## The Clubhouse at Flying Horse North Final Drainage Report

May 2025

PCD File No. PPR-259

## 100 YEAR OUTFALL TABLE

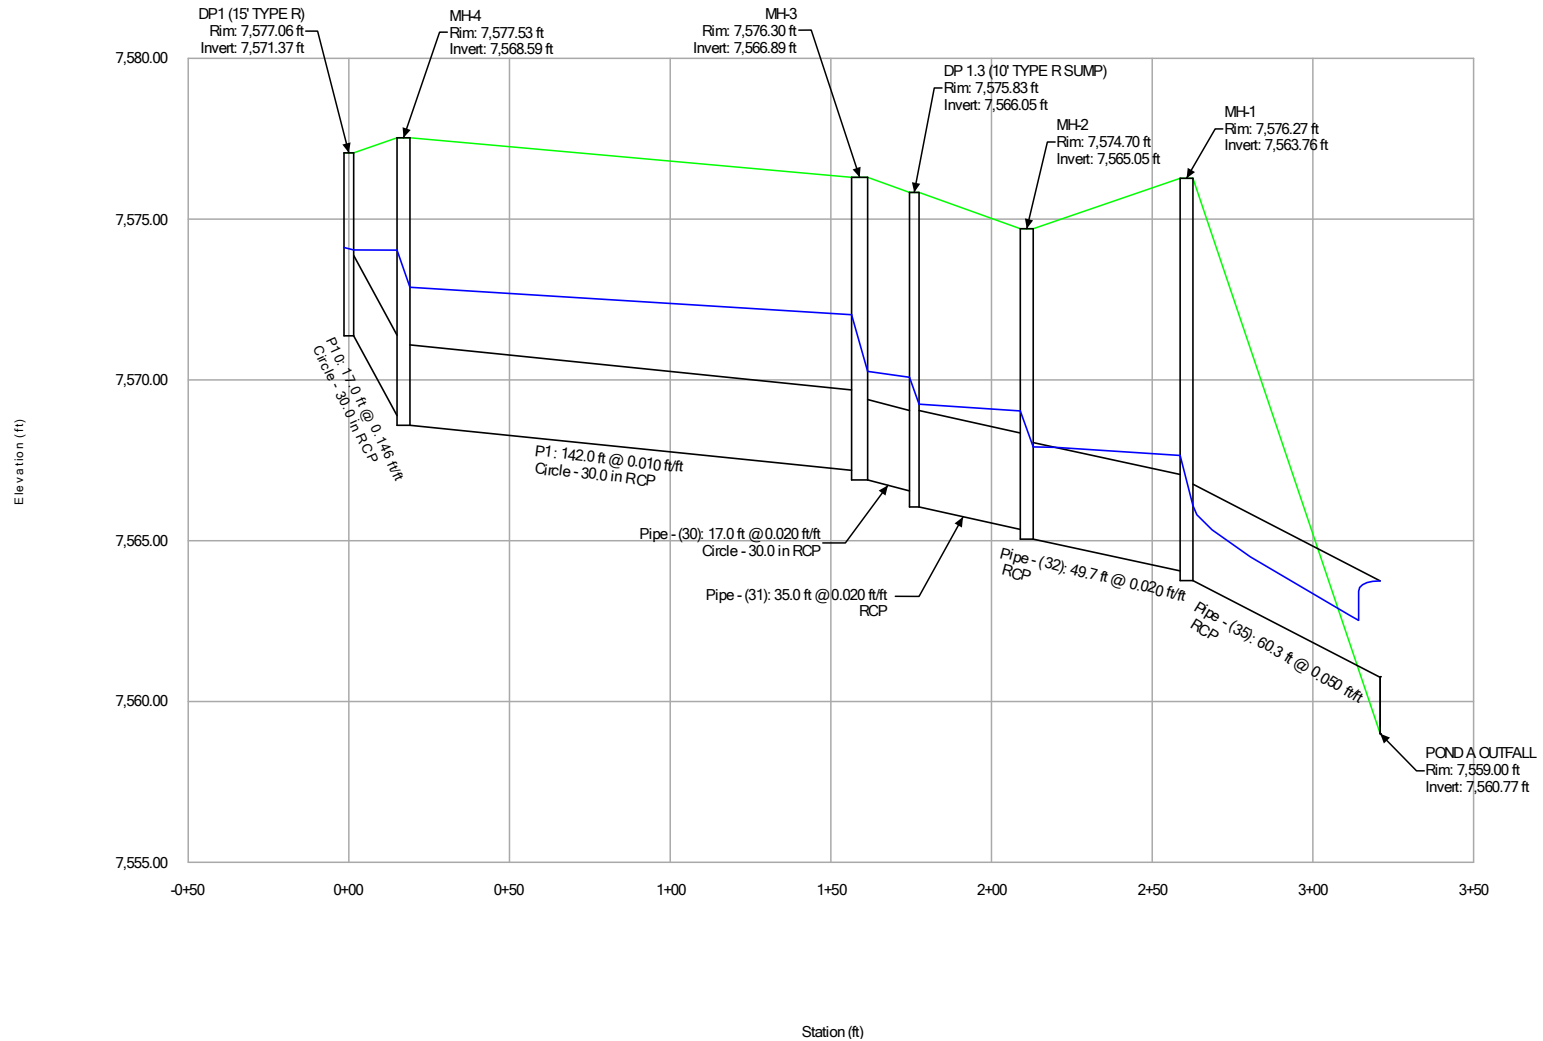
revise to deviation

HRG Response:  
Revised.

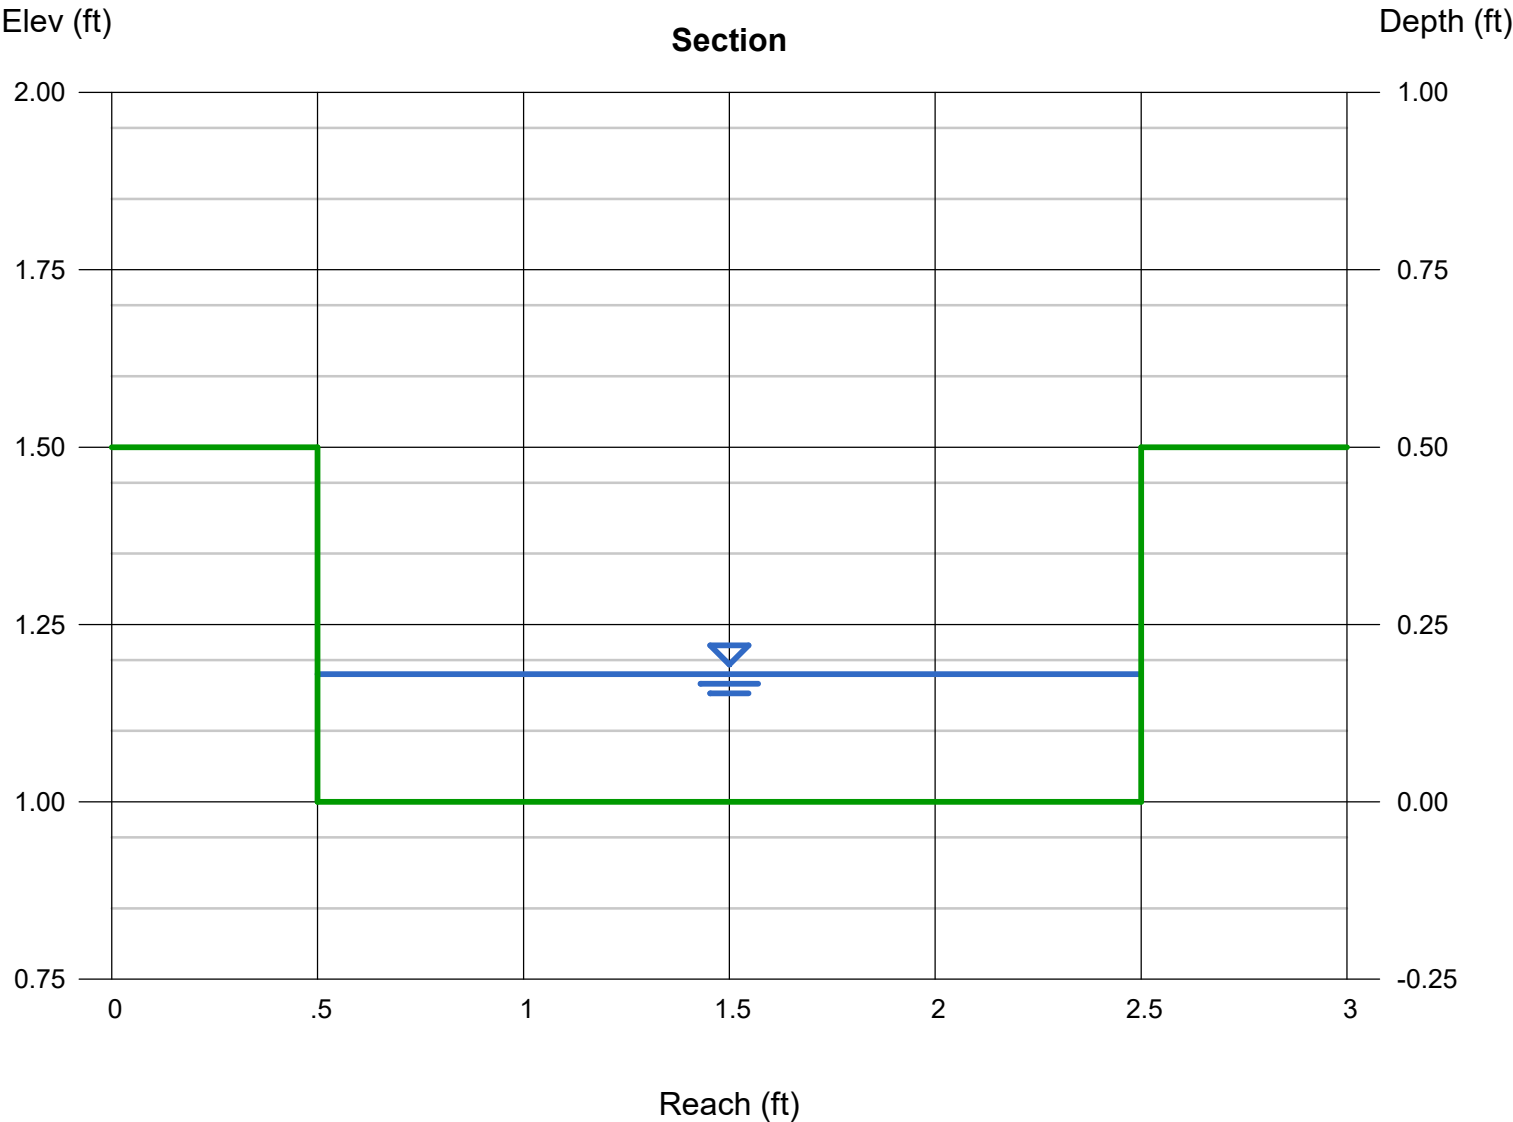
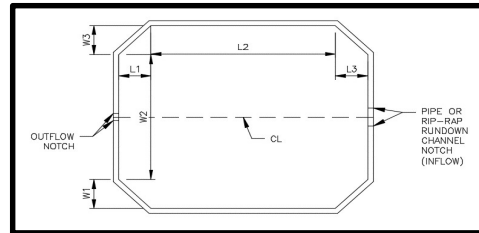
Revised to maintain  
drain time of 4-5 min.

show this in a detail in  
GEC Plans

**HRG Response:**  
Details of modifications to  
pond added to GEC.
